Docket No. 50-389

AMENDMENT TO FACILITY OPERATING LICENSE

Amendment No. 7  
License No. NPF-16

SAFETY EVALUATION BY THE OFFICE OF NUCLEAR REACTOR REGULATION

Figure 1. Spent Fuel Pool Layout

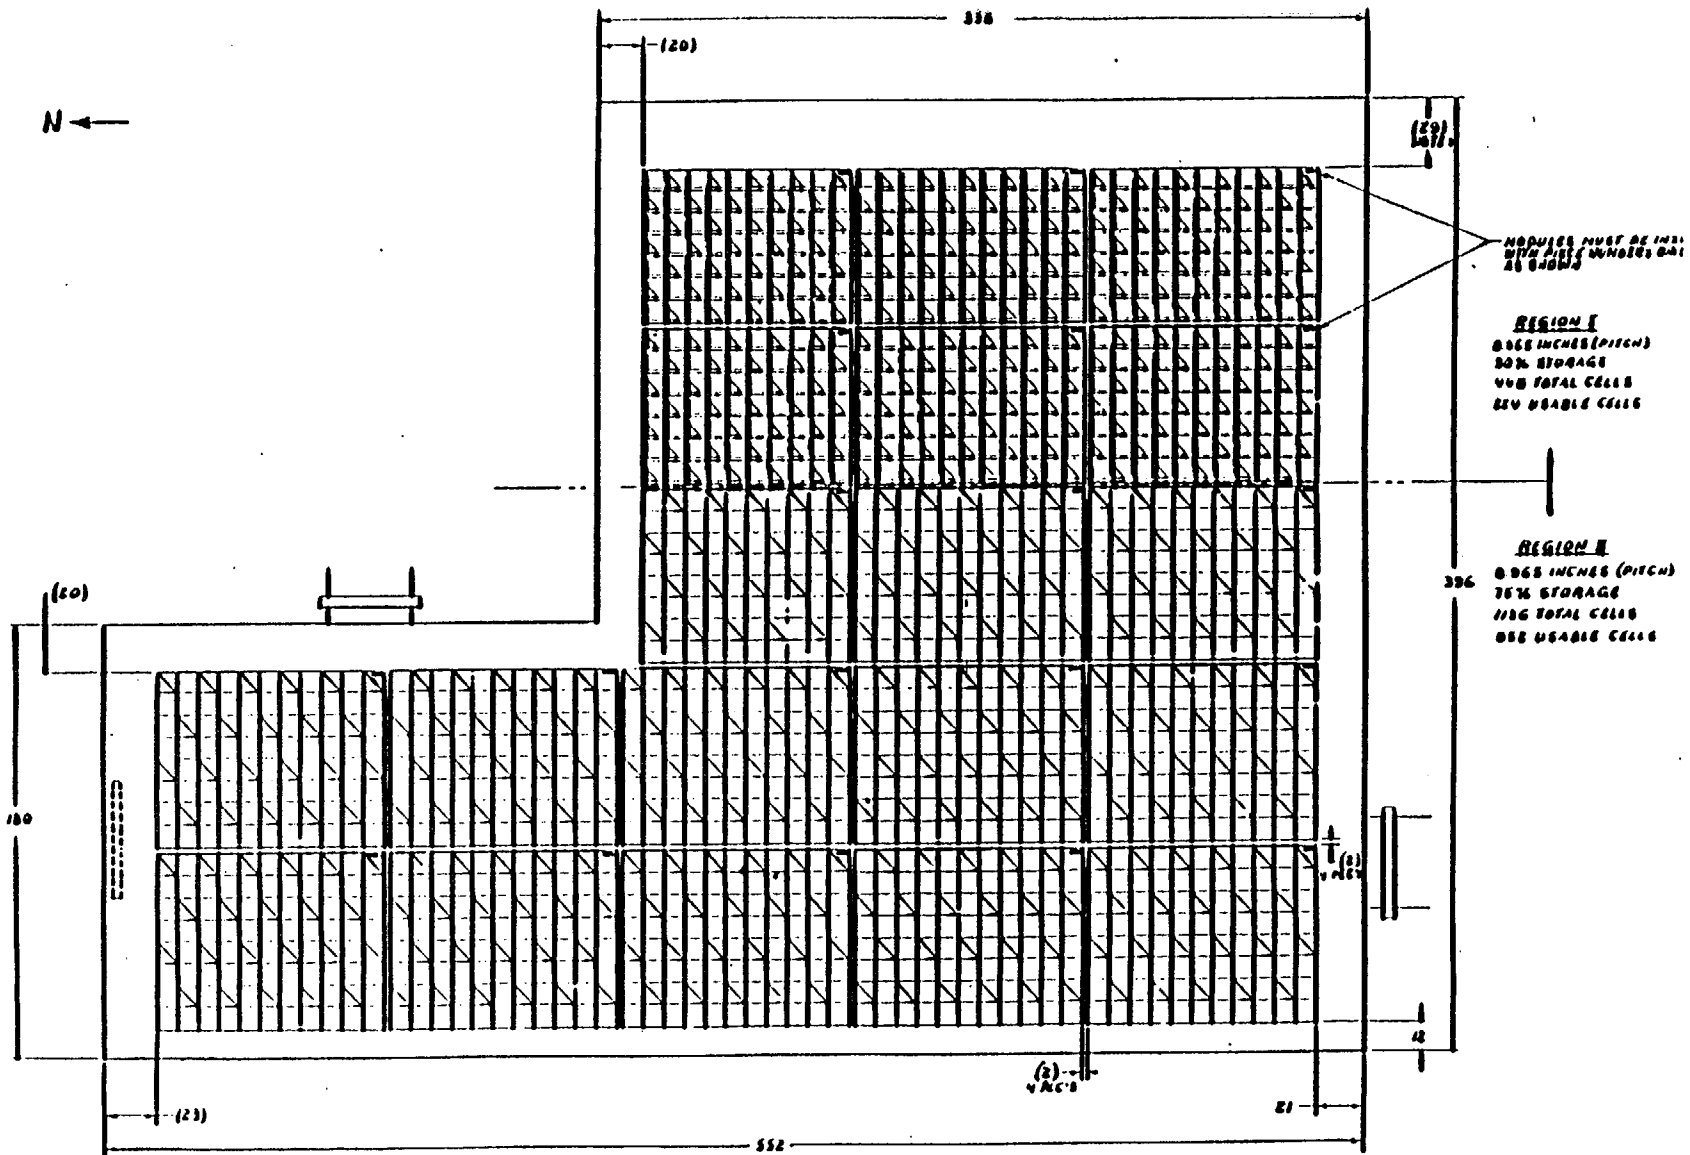
The layout of the spent fuel pool at St. Lucie Unit 2 is shown in Figure 1. The pool is divided into Regions I and II. Region I is the high-enrichment core off-load region. In Region I, the fuel assemblies are stored in every other location in a checkerboard configuration (see Figure 1). Cell blocking devices are inserted in the unused cavities to prevent inadvertent insertion of fuel into these locations. The modules in Region II are used to store irradiated fuel below specific reactivity levels. Cell blocking devices are placed in every fourth cavity in this region.

The Licensee performed the seismic analysis on the 8 x 11 module. Two finite element models were used to carry out the seismic analysis.

Figure 2. Plot of the SAP IV Finite Element Model

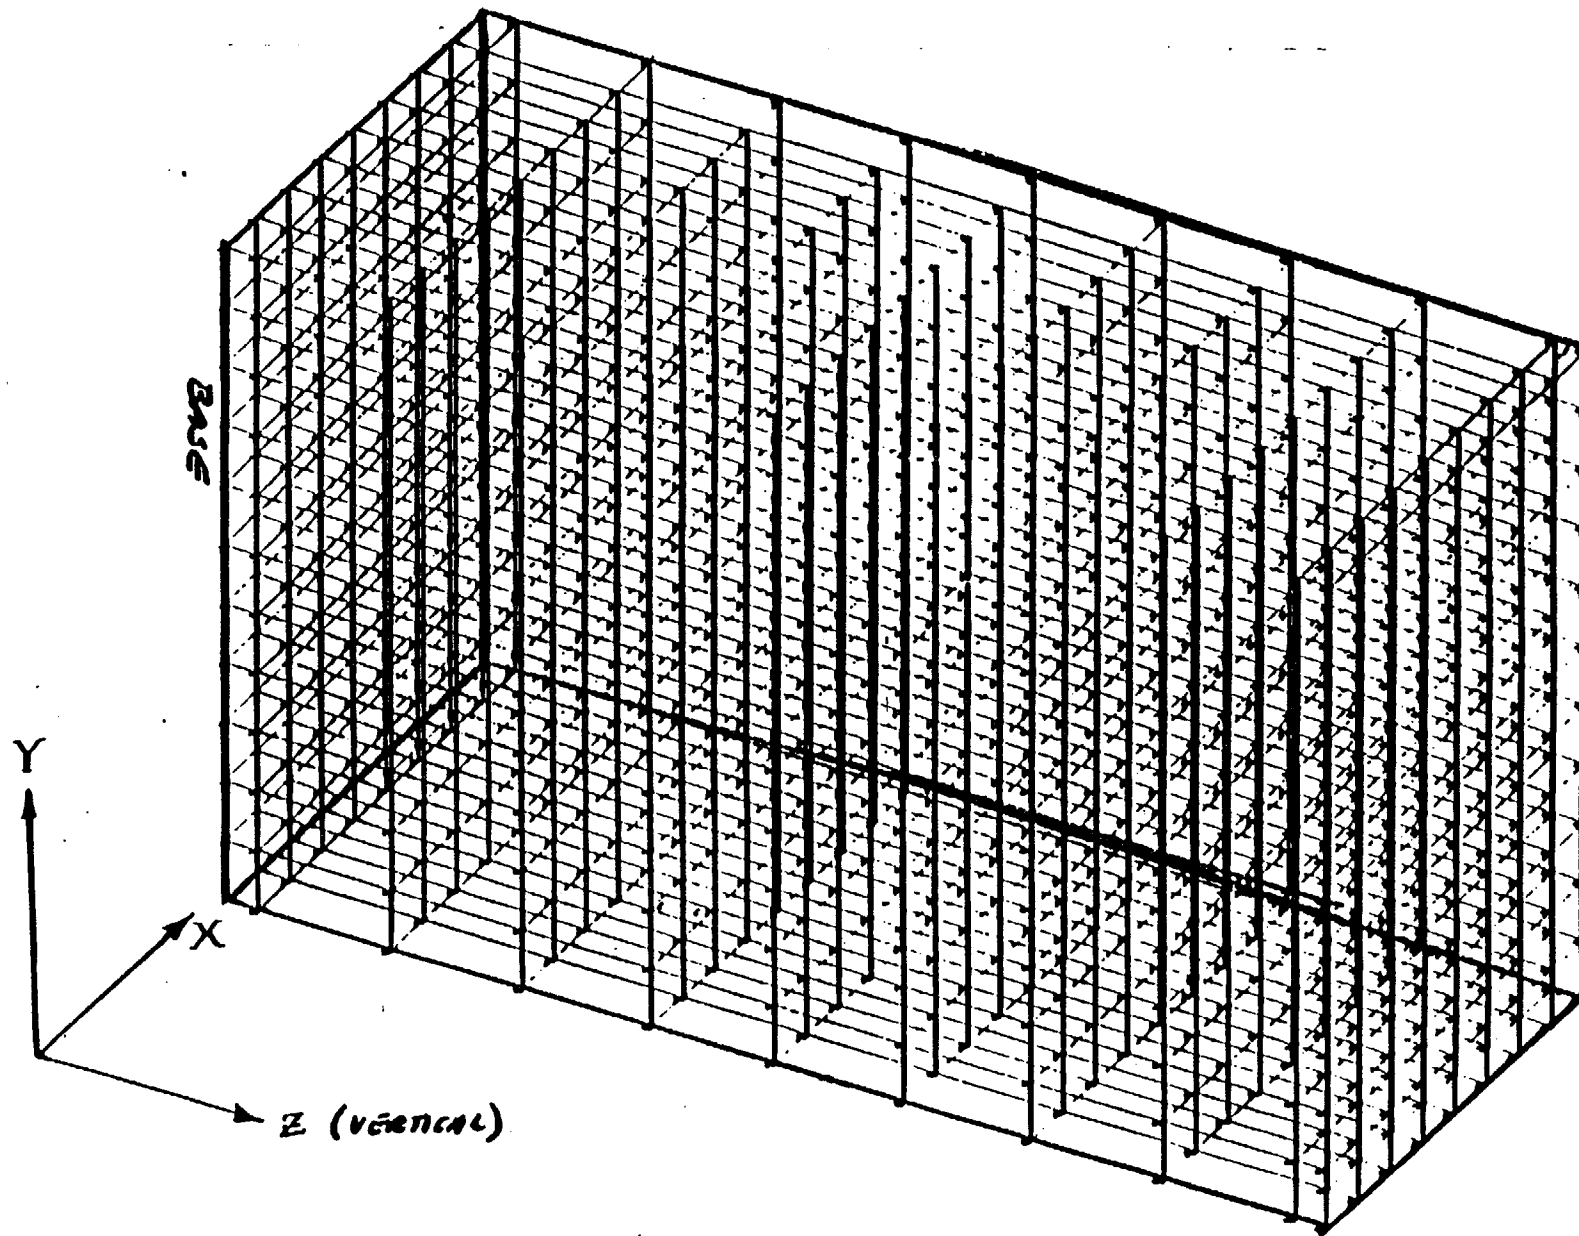
The SAP IV model, a linear three-dimensional model of the module shown in Figure 2, served two purposes: (1) to generate the dynamic characteristics of the module structure in air and (2) to serve as a stress model to identify maximum stresses and their locations. The dynamic analyses (time history and response spectrum) of the module were conducted by the CESHOCK model which is a two-dimensional representation of an individual fuel cell shown in Figure 3. This is a nonlinear model with equivalent dynamic characteristics (natural frequencies and mode shapes) derived from the SAP IV model.

A linear three-dimensional model was developed to simulate the major structural characteristics of an unloaded module in air. The SAP IV computer code [3] was used to generate this model. The walls of fuel cells were simulated by plate elements and beam elements were used to represent the fuel support bars. A computer plot of the model is shown in Figure 2.

Figure 3. CESHOCK Model of an Individual Fuel Cell

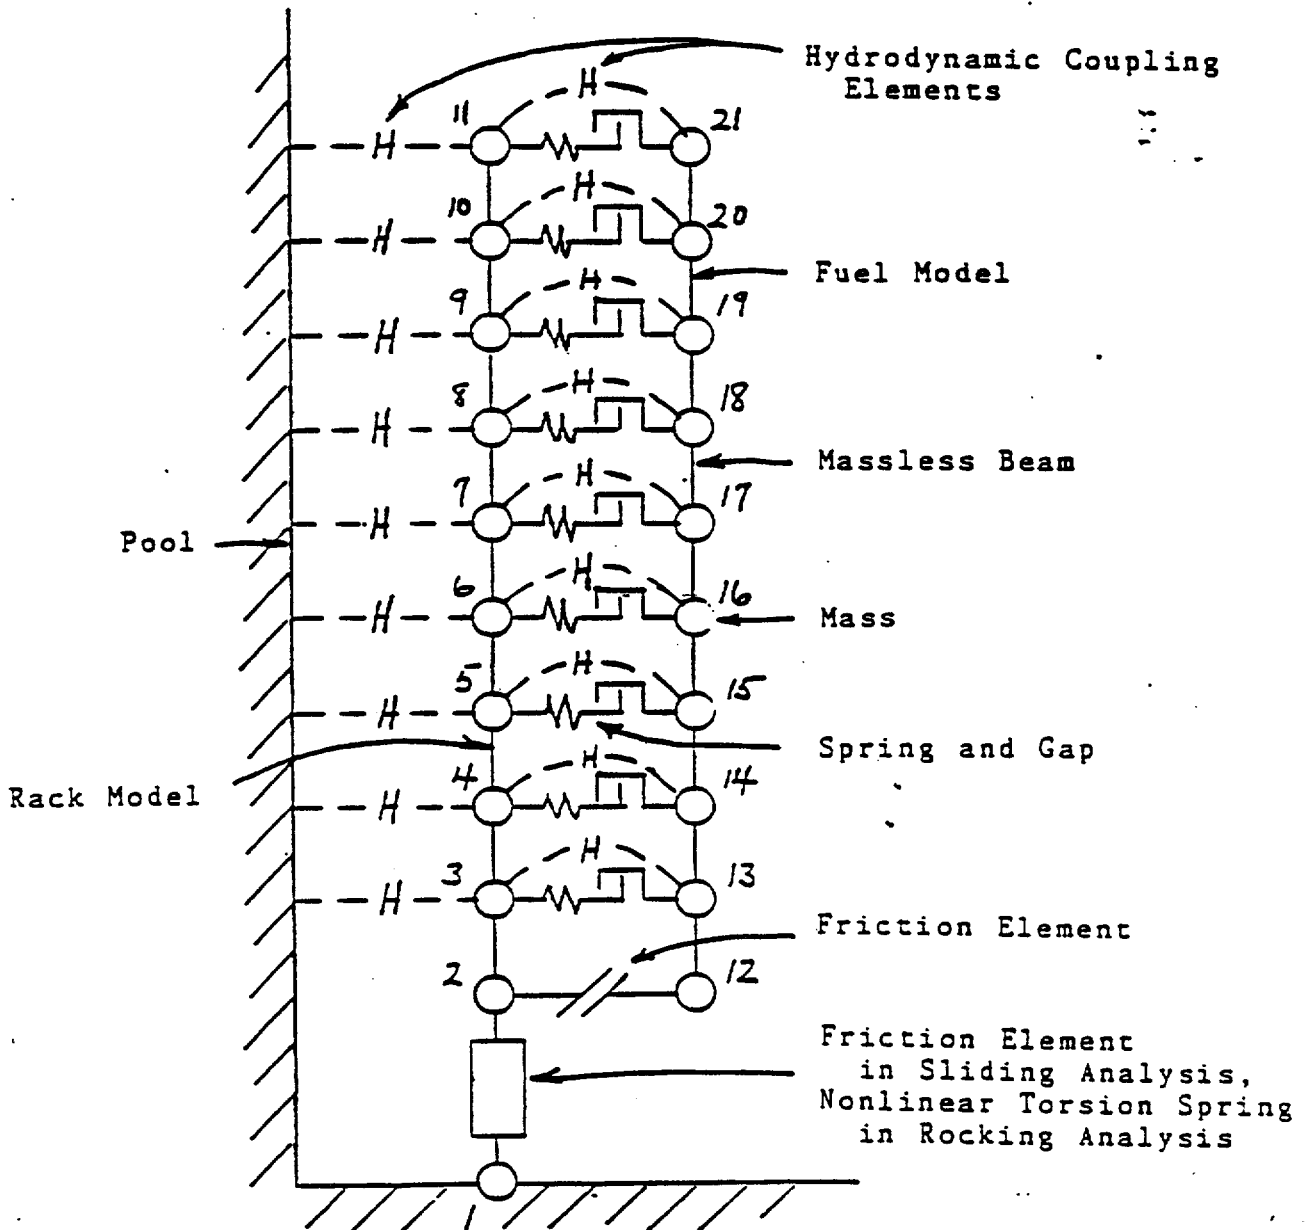
A schematic description of the CESHOCK model is shown in Figure 3. The masses of the fuel cells and fuel assemblies were discretized in the CESHOCK model [4]. The spent fuel pool was represented by node 1. Mass nodes 2 through 11 were used to represent the fuel cells. These mass nodes were linked by flexible elements. Similar arrangements were made to simulate the fuel assemblies by mass nodes 12 through 21. The hydrodynamic couplings between the fuel cells and fuel assemblies as well as the module and pool wall were designated by element H. Nonlinear gap-spring elements were used to represent the possibility of impacting between the fuel cells and fuel assemblies. A friction element coupled the base of the fuel assemblies to the module. The coupling element at the interface between the base of module and the pool liner represented a friction element in a sliding analysis and a nonlinear torsion spring in a rocking analysis. The possibility of the module lifting the pool liner was not included in this model because the Licensee claimed that its seismic analysis indicated no liftoff for a fully loaded module [5].

Figure 4. Maximum Stress Location in the Module

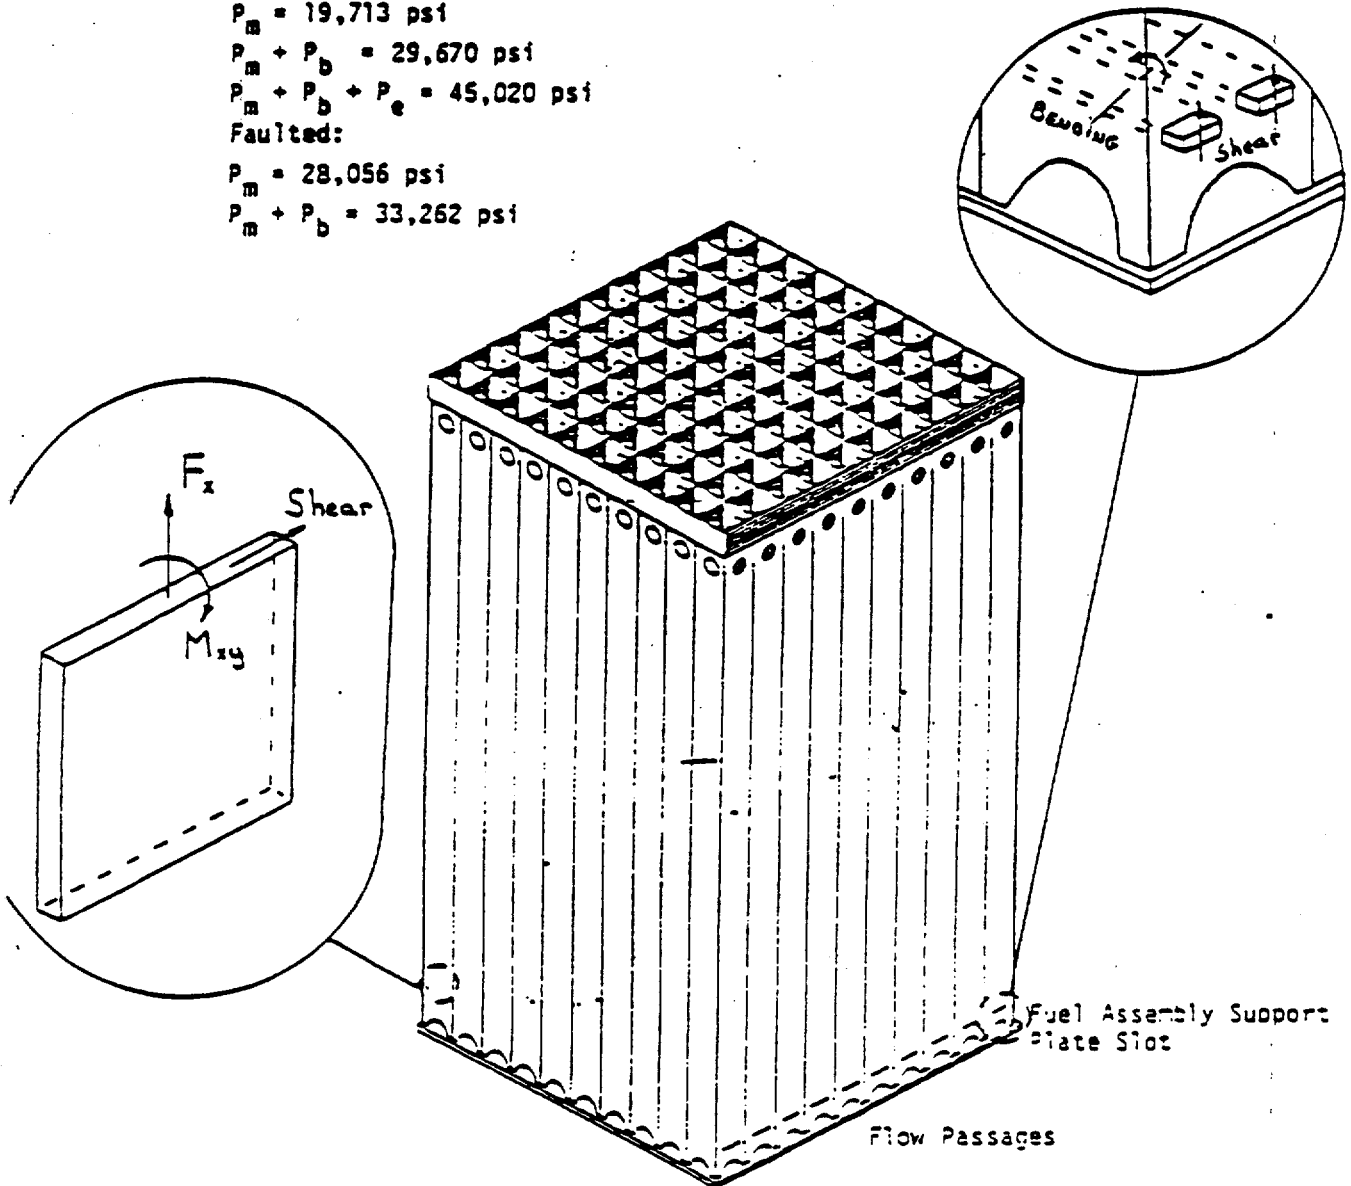
The maximum stresses were found at the plate elements of the fuel cell wall at an elevation near the fuel lower end fitting and support bar interface [5]. The maximum stress points were clustered near the module/liner support points (see Figure 4).
